PLANT NAME: THREE MILE ISLAND - UNIT 1

Three Mile Island Nuclear Station Unit 1 (TMI-1)
Operating License No. DPR-50
Docket No. 50-289
Cask Drop Analysis Additional Information

CASK DROP ANALYSIS

ADDITIONAL INFORMATION

FIGURE 1

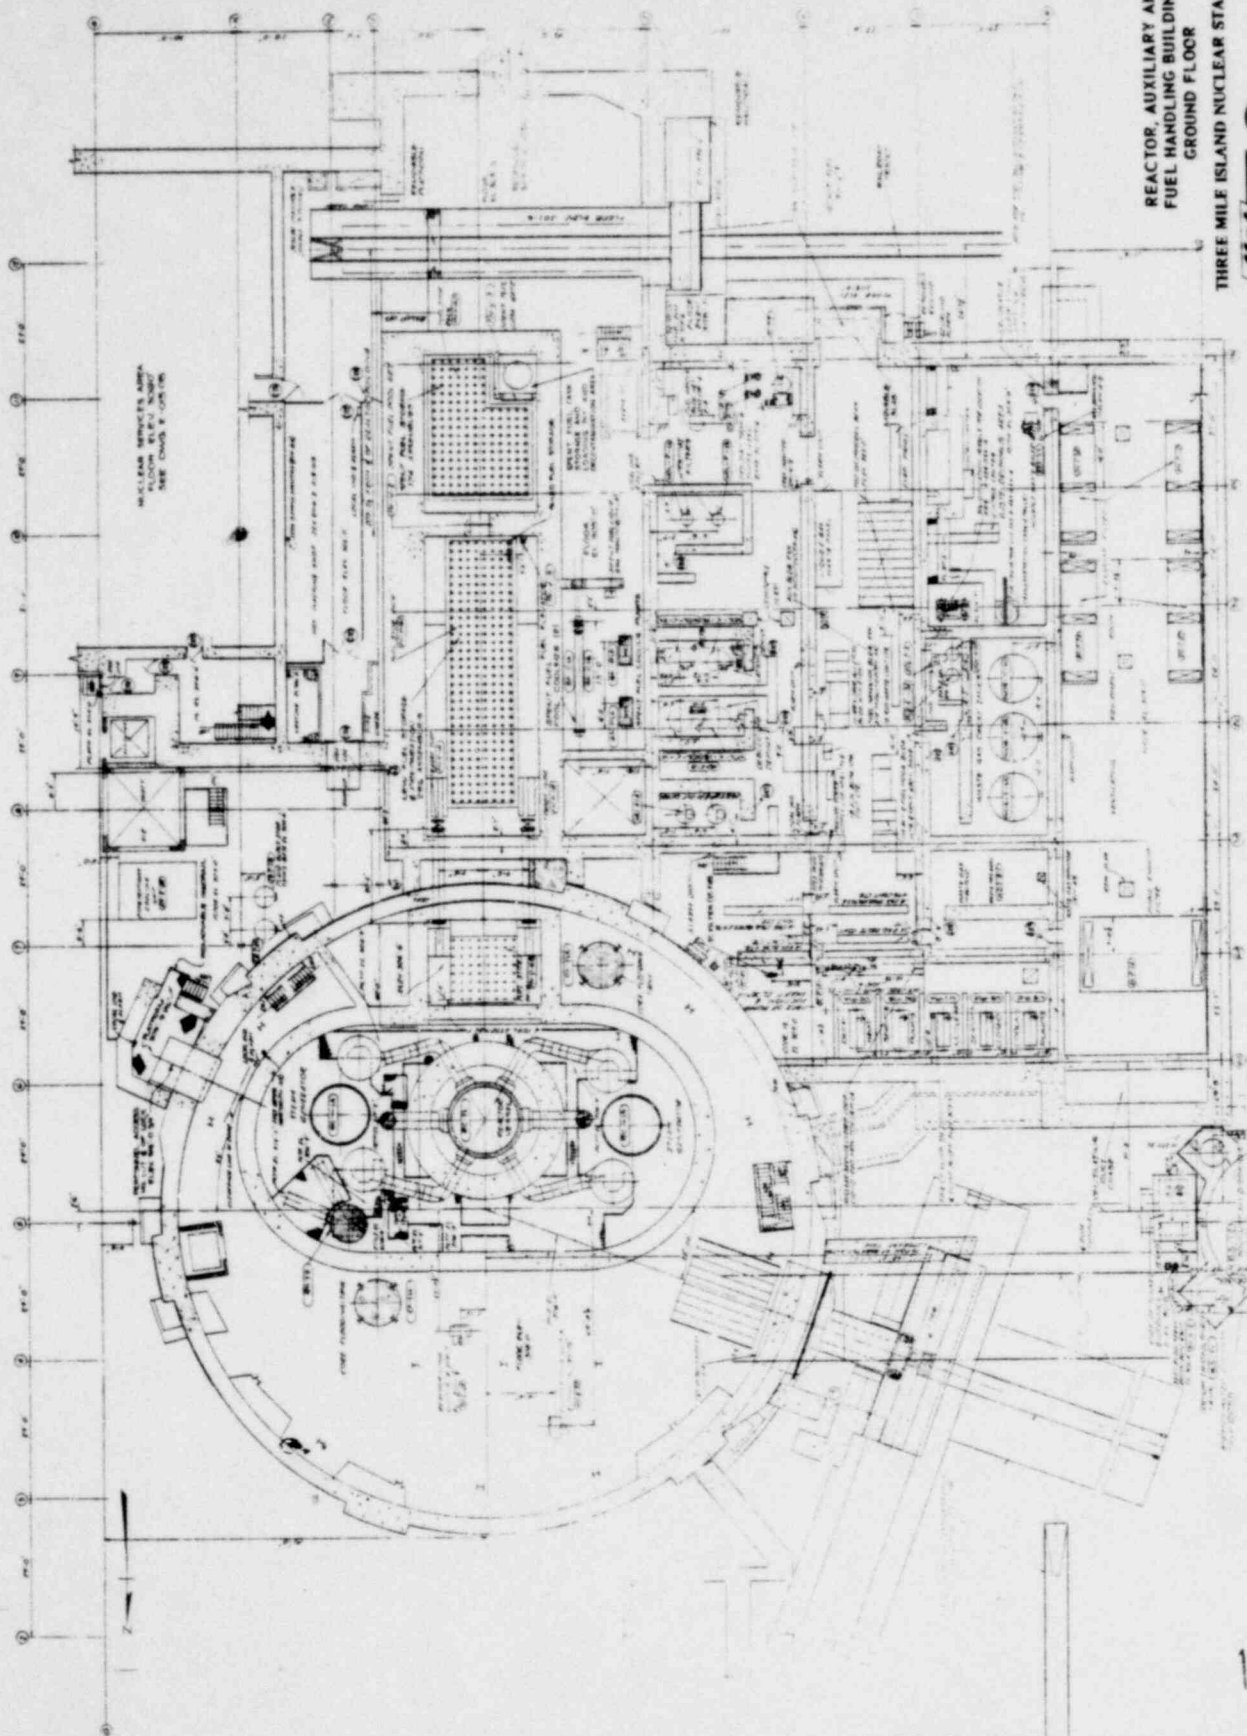
- 1.1 Provide one drawing showing the relative location of the following areas of Unit 1: (i) the new fuel storage areas; (ii) the spent fuel storage pool; (iii) the spent fuel cask storage and loading pit; and (iv) the specific location of the cask decontamination area.

- 1.2 To adequately evaluate the potential for unsafe conditions occurring in Unit 1 following a cask drop accident at any point along its revised path of travel between the transporter, the newly located decontamination area, and the spent fuel cask loading pit, superimpose the travel paths of the shipping cask for Unit 1 and 2 within the Unit 1 building on the drawing requested above.

- 1.3 Verify that the path of travel of the spent fuel cask from the transporter to the Unit 2 building has not changed due to these proposed changes or describe, discuss and demonstrate that no safety related consequences could result from these changes.

2.2 Demonstrate that following a cask drop accident the cask will not tip, roll, or impact on Unit 1 temporarily stored new fuel in a manner which would lead to a criticality accident. In particular, state a maximum

The requested information is shown on Figure 1.

The travel path of the shipping cask for Unit 1 and 2 within the Unit 1 building is shown on Figure 1.

The path of travel of the spent fuel cask from the transporter to the Unit 2 building remains as shown in the TMI-2 FSAR, Volume 8, Section 9.1.4.2.2. See Figure 1.

As shown on Figure 1, the area south of the railroad track is no longer designated as a temporary storage area for new fuel. New fuel will be receipt inspected in this area and then will be transferred to the new fuel storage racks shown in Figure 1 or to the spent fuel pools. No new fuel will be permitted in the receiving/shipping area during cask handling operations. Therefore the questioned impact of an accident on Unit 1 temporarily stored new fuel cannot occur.

FSAR Figure 9-18A will be revised showing the new key interlock limits of travel of the crane. This will be accomplished by substituting Figure 1 for 9-18A. Additional details are also shown in Figures IV-4 and IV-6 of the February 14, 1976, submittal.

FIGURE 1-3

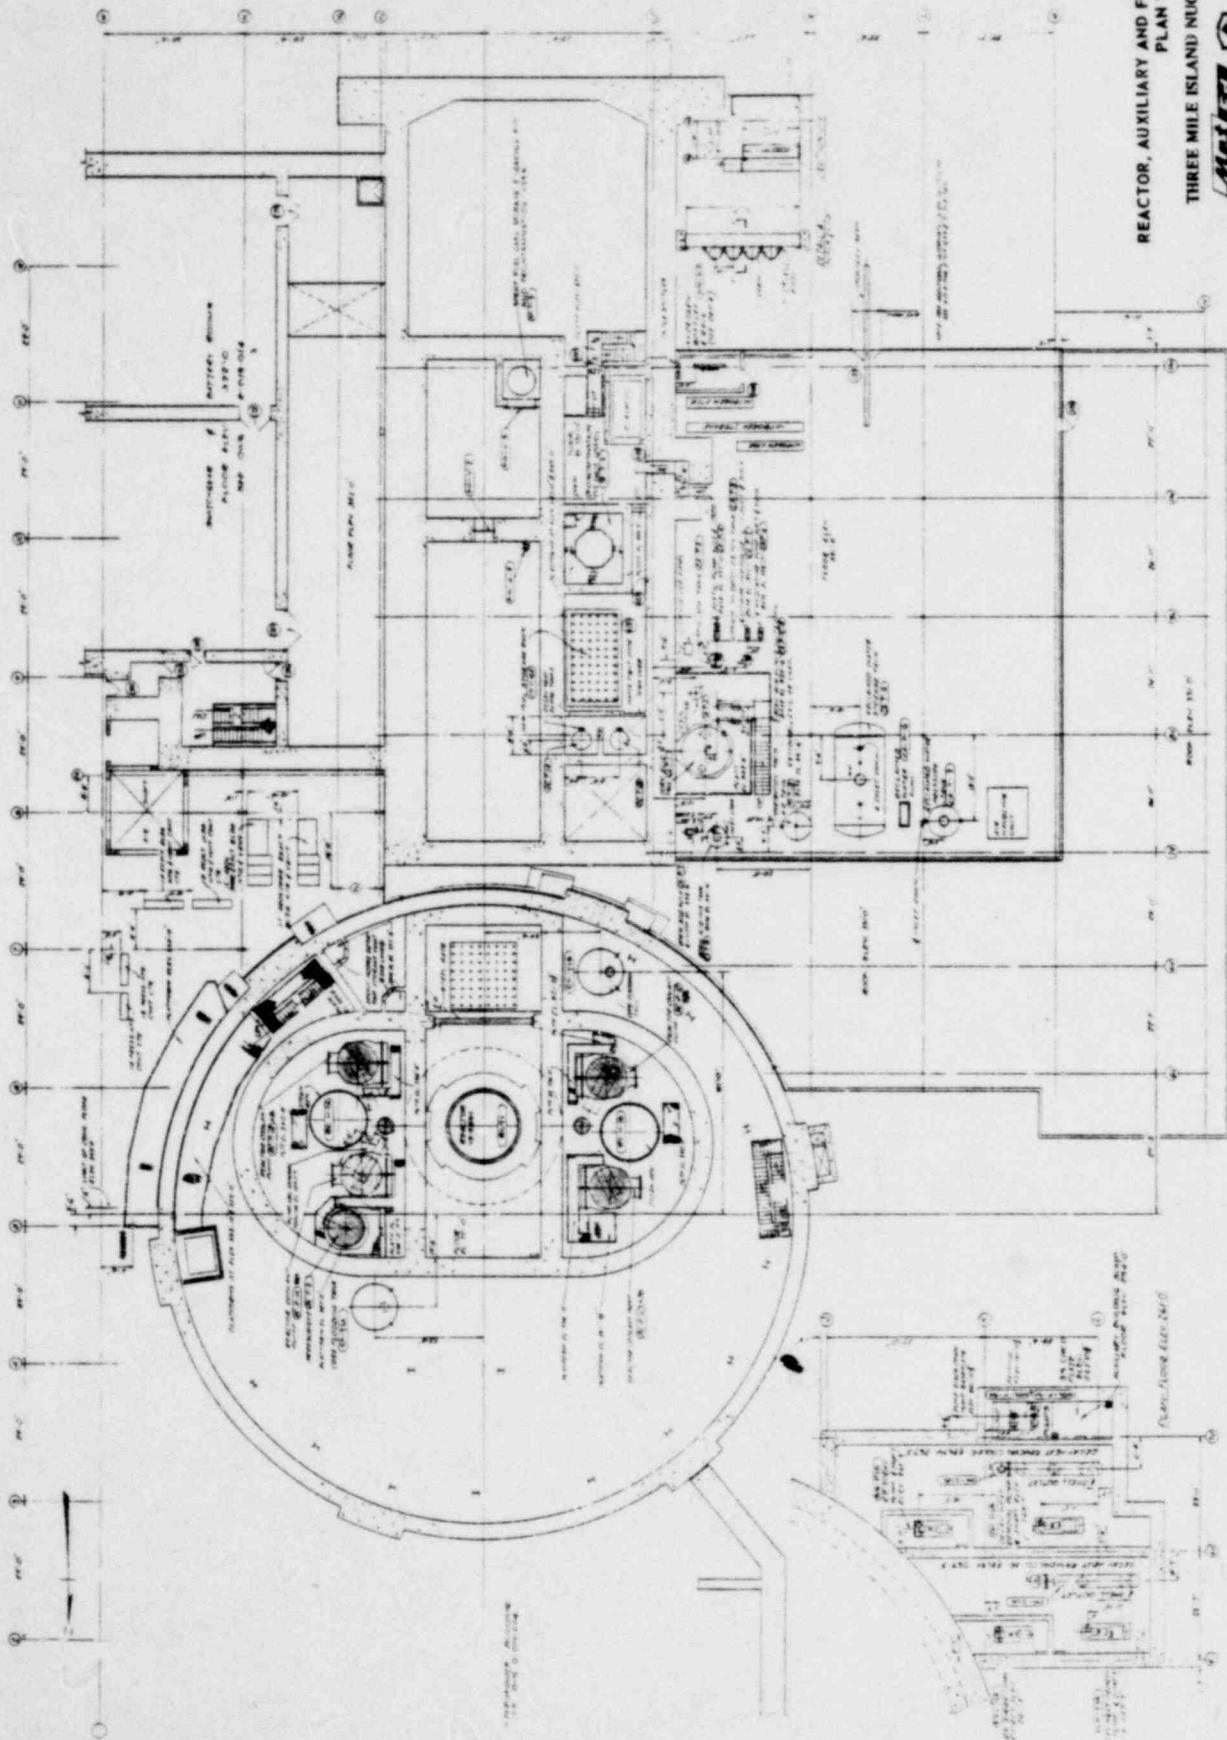
submittal. Further, FSAR Figure 1-3 shows that the Unit 1 temporary new fuel storage area is located parallel to the transporter railroad tracks and could be in the path of the spent fuel cask as it travels to and from the Unit 1 decontamination area as well as the corresponding work stations in Unit 2.

Figure 1-3 TMI-1 FSAR

- (1) "Temporary New Fuel Storage Rack" changed to "Receiving/Shipping Area."
- (2) "Spent Fuel Cask Storage Area" changed to "Spent Fuel Cask Storage & Loading Pit and Decontamination Area."

FIGURE 2-A

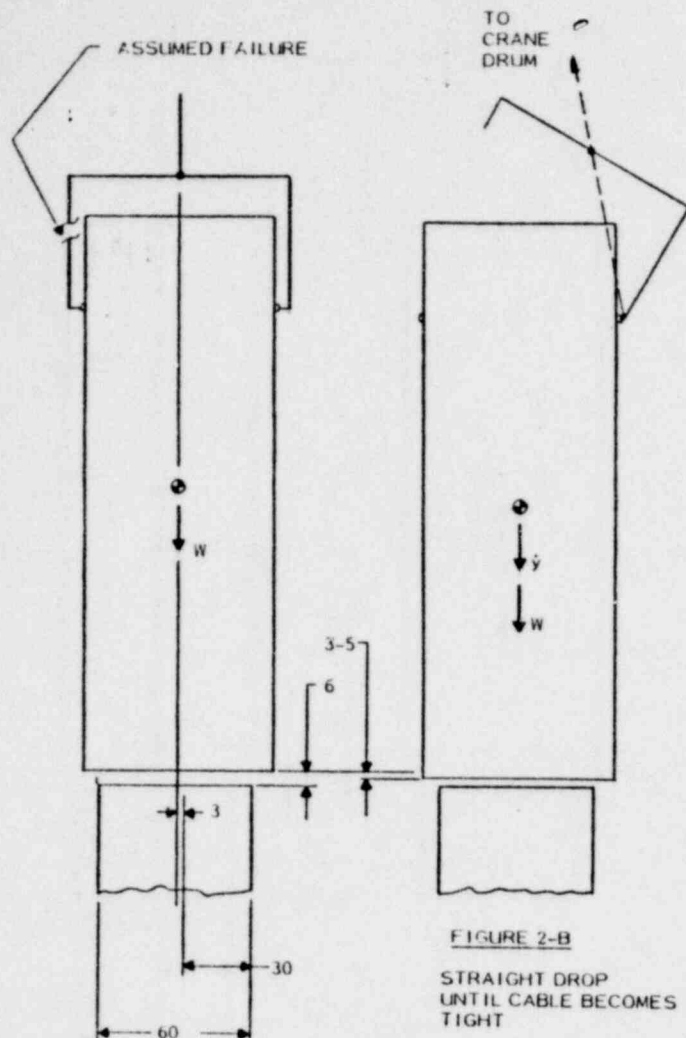
12.0 Provide a summary of the cask stability analysis when the cask is dropped on the south wall of the "B" spent fuel pool for both eccentric and straight drop conditions."

1. The cask bottom surface is assumed to be raised 6 inches above the top of the spent fuel pool wall and the cask center of gravity is assumed to be located 3 inches from the center of the 6-inch wide transfer path as shown in Figure 2a.
2. The lifting trunnion or lifting yoke arm on one side of the cask is assumed to fail. This lets the cask drop straight down 3 to 5 inches (depending on the cask involved) until the resulting slack in the system is removed, i.e.,

a straight line of action is established between the unfailed cask trunnion, the center of the lifting yoke and the cable drum as shown in Figure 2b. At this point, the cable becomes tight.
